Appendix A19 – TSC Pre-lodgement Meeting Minutes

Proposal: State Significant Development SSD-10398 for expansion of the Hanson's Sand Quarry (Phase 5 to 11).

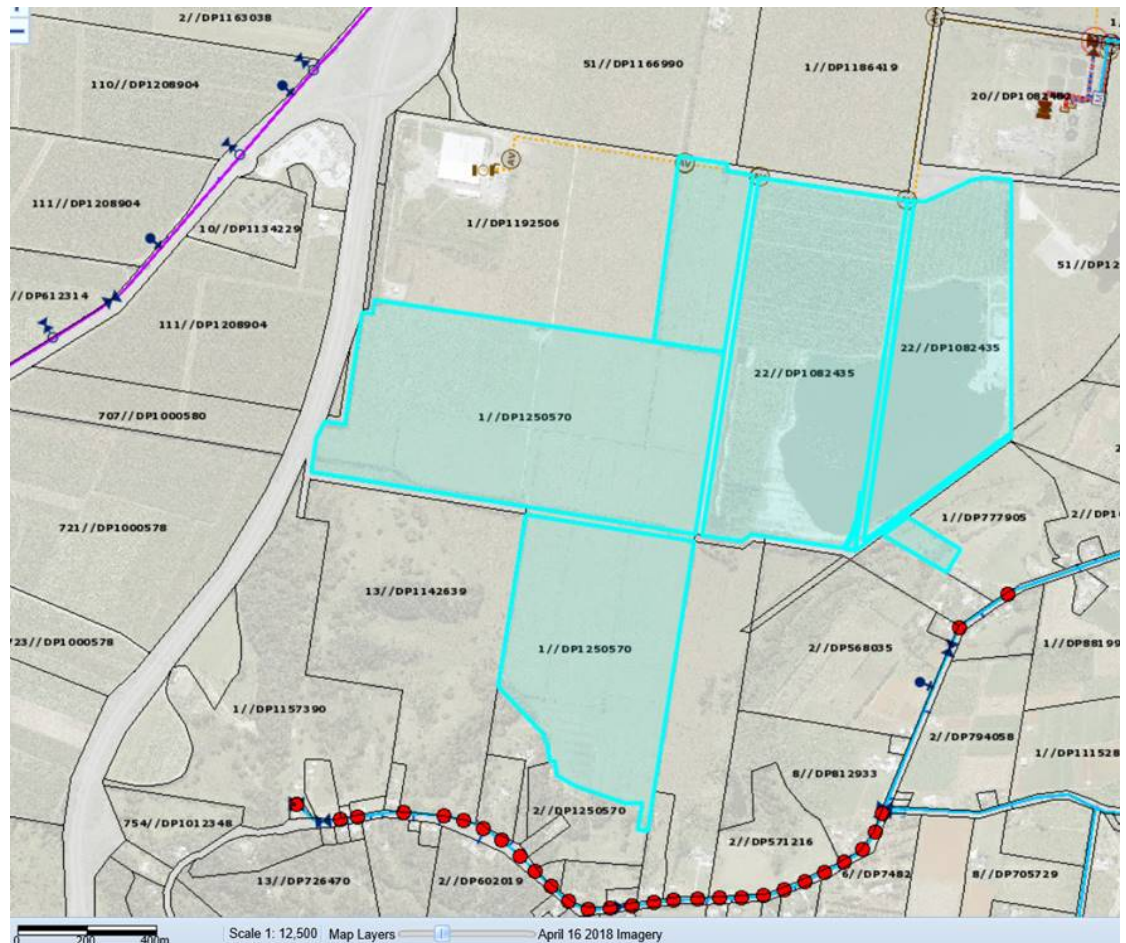
- ***Does Council have any as built or WAXE detail of the ABLP waste discharge infrastructure that leads to the Kingscliff STP?***
- ***Does Council have any as built or WAXE detail of any TSC infrastructure running through or near the site boundaries (i.e. sewage outfall pipelines, etc)?***

In regards to as built or WAXE detail of any TSC infrastructure running through or near the site boundaries (i.e. sewage outfall pipelines, etc.), there are no sewer or water mains immediately within the sites vicinity. See GIS screenshot below. Please note the presence of the aforementioned private (non TSC owned) rising main near the northern boundaries of the site.

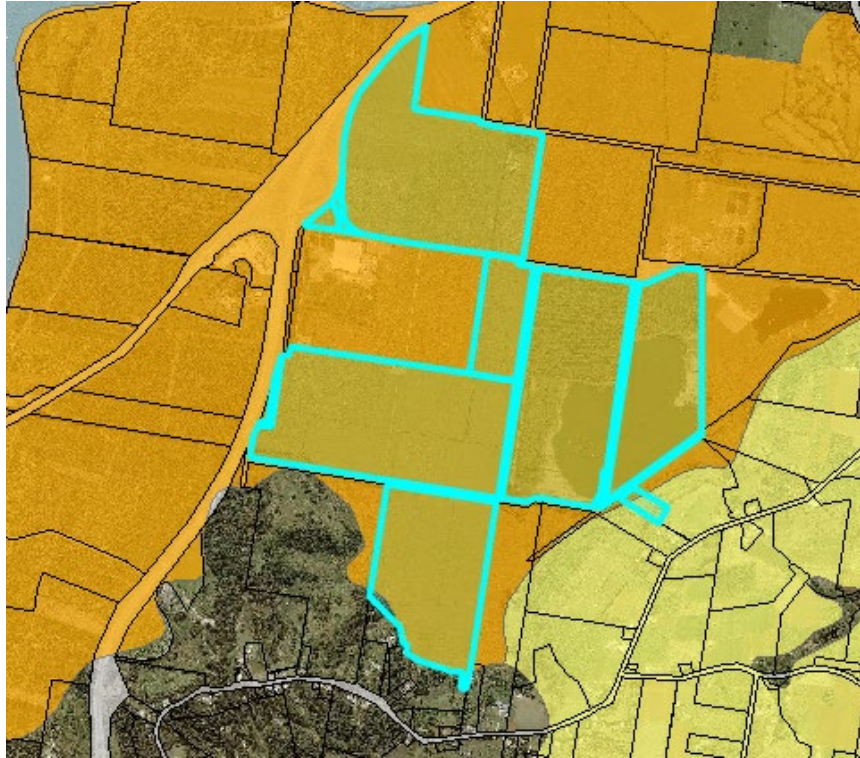
A copy of the concept plan is attached and the following specific comments were made in relation to that plan:

- Far North Coast Regional Strategy. Whilst the Strategy may identify *Regionally Significant Extractive Resources* in the Chinderah Road area, it is also noted

that the Strategy provides for the protection of productive farmland from development pressures, with the subject area being mapped as *Regionally Significant Farmland*.

- North Coast Regional Plan 2036. Concern is raised with the suitability of the proposed development and the impact of sterilizing the land for future uses and loss of agricultural land.
- A significant portion of the site is recognized as Regionally Significant Farmland under the Northern Rivers Farmland Protection Project.

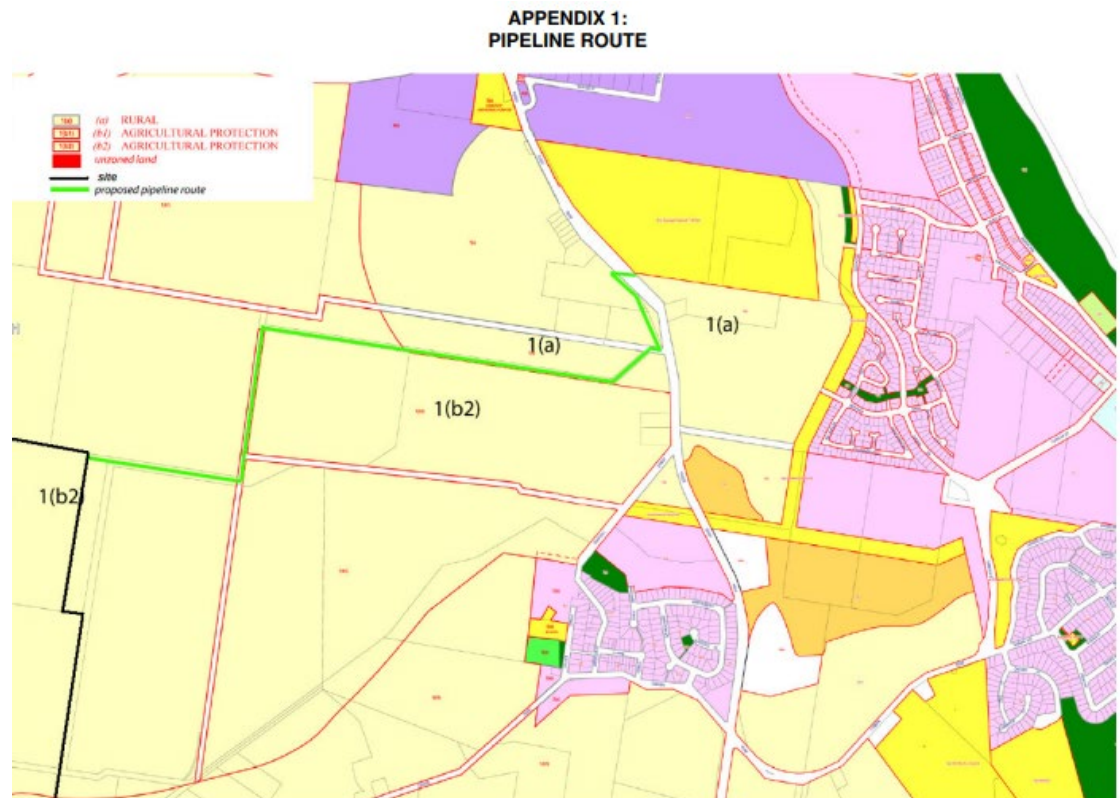
- Visual amenity needs to be considered. A visual amenity analysis needs to be undertaken, not only from the nearby Cudgen ridge to the south east, but also from the elevated ridges to the north west. Consider cumulative impacts of the scale of the proposal along with the adjoining proposal on Gales land and proposed Chinderah quarry to the north of the subject site (SSD-8471). These sites are mapped as being visible from a number of publicly accessible viewing

locations across the shire, as shown on the below map. Any application would also need to address the Draft Scenic Landscape Strategy.

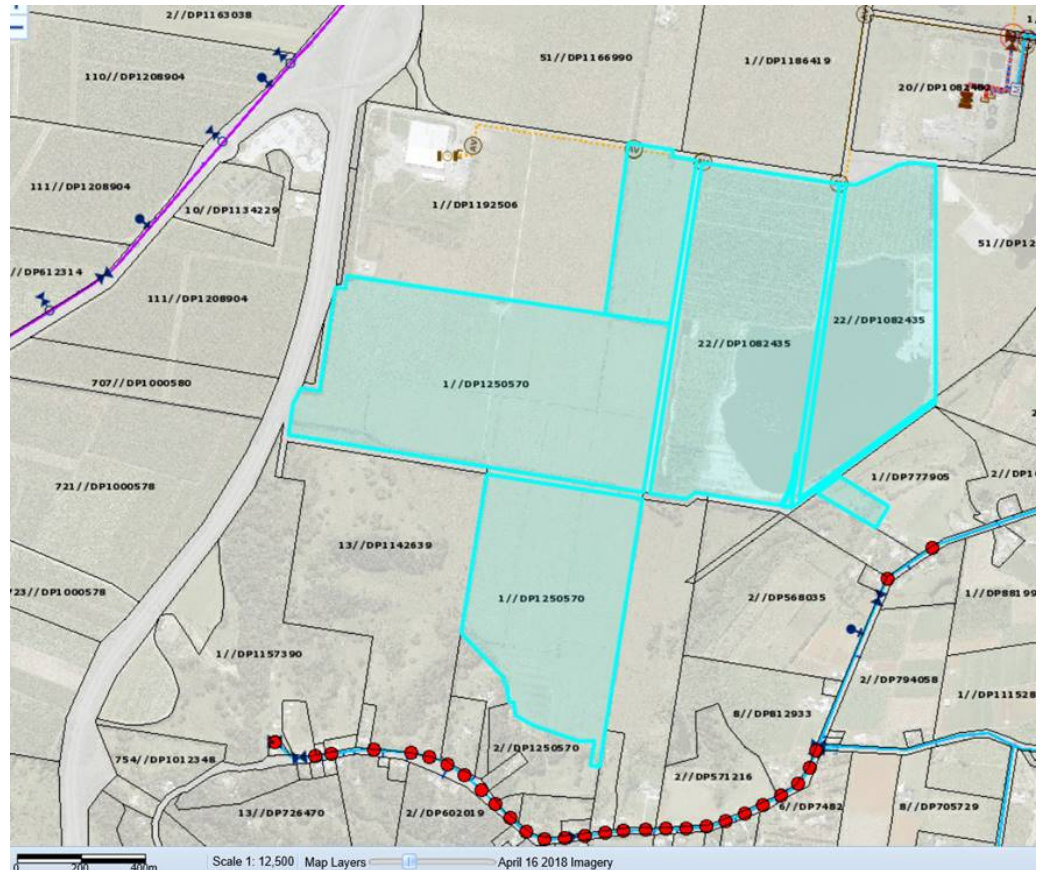
- The proposed haulage route and extraction footprint extends within an approximate 9000m² unit of candidate Endangered Ecological Community (EEC) - Swamp Sclerophyll on Coastal Floodplains of the NSW North Coast, Sydney Basin and SE Corner Bioregion identified as Broad-leaved Paperbark Closed Forest to Woodland under the Tweed Vegetation Management Strategy mapping 2009. The unit is also identified as Preferred Koala Habitat under the Tweed Coast Comprehensive Koala Plan of Management (KPoM). Impact upon the red flagged area is unlikely to be supported.
- A unit of vegetation straddles the southern boundary of Lot 1 DP1250570 and unformed road reserve. Vegetation classification requires field verification.

Where the unit is representative of an EEC a 30 m ecological buffer should be established. Where not consistent with an EEC, a 20 m buffer should be provided. Ecological buffer widths appear to be either negligible or extending to a maximum distance of approximately 15m. Any 'Open Space' zone (assuming managed open space) is not to form part of the core ecological buffer – assumed as 'vegetation buffer' on the plan, that would be subject to protection and habitat management in accordance with DEC 9 and C10 of DCP A19 including any red flagged value where occurring onsite.

- A unit of vegetation occurring on the floodplain (Q100) within the south-western corner of Lot 1 DP1250570 and extending across the adjacent offsite Lot appears to occur within the extraction footprint. An additional unit further to the south is afforded an approximate maximum 20 m 'vegetation buffer'. Both units area mapped as Preferred Koala Habitat under the KPoM. Both vegetation units should be afforded full 30 m ecological buffers where confirmed to be analogous with an EEC. Where not consistent with an EEC, a minimum 20 m buffer should be provided and the core value protected and managed.

- To the southern boundary of Lot 1 DP1250570 remains a remnant unit of vegetation likely to be representative of a candidate EEC – Lowland Rainforest on Floodplain in the NSW North Coast Bioregion. A 30 m ecological buffer should be afforded to this rainforest vestige. Current plans show an approximate 20 m wide 'vegetation buffer' which is unlikely to be sufficient to mitigate development impact upon the function and integrity of an EEC unit.
